# Consideration of Comments

## Order No. 754 – Request for Data or Information

The Order 754 Drafting Team thanks all commenters who submitted comments on the Request for Data or Information. These comments were posted for a 45-day public comment period from December 22, 2011 through February 6, 2012. Stakeholders were asked to provide feedback through a special electronic comment form. There were 56 sets of comments, including comments from approximately 130 different people from approximately 97 companies representing all 10 Industry Segments as shown in the table on the following pages.

Figure 1: WECC Bus Three Phase Short Circuit MVA  
2009HS3 Base Case

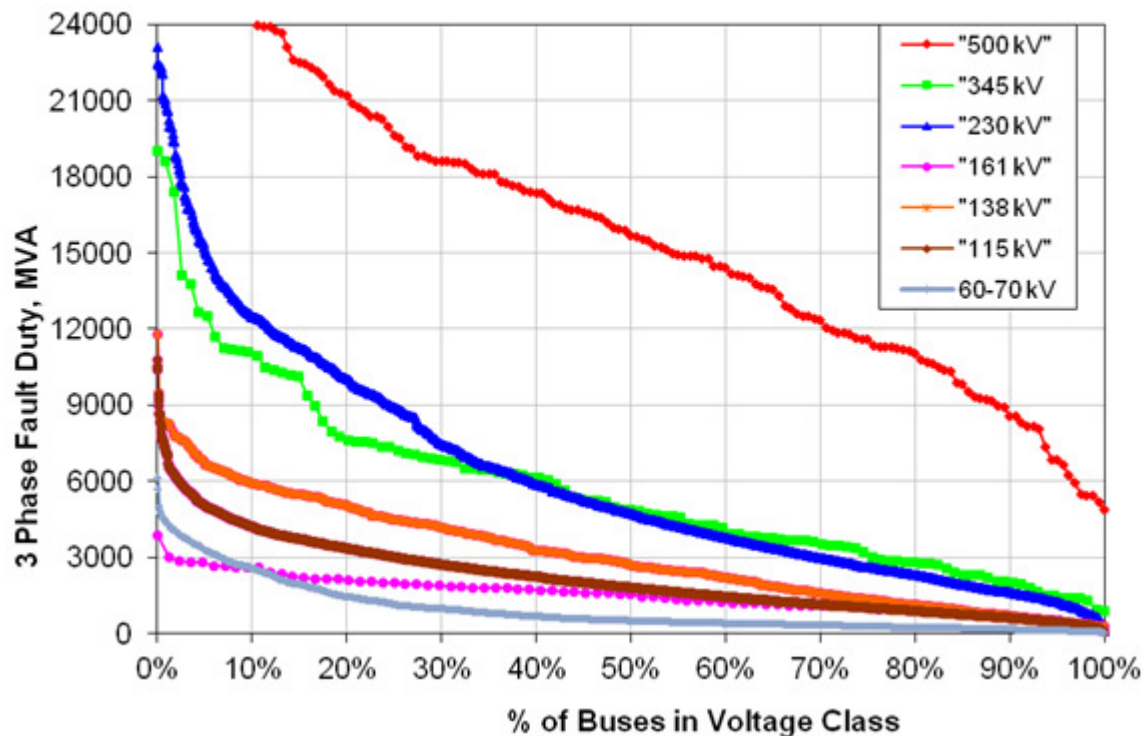
Additional Submittal: Figure 1/PacifiCorp/Sandra Shaffer

<b>Response:</b> See summary response.
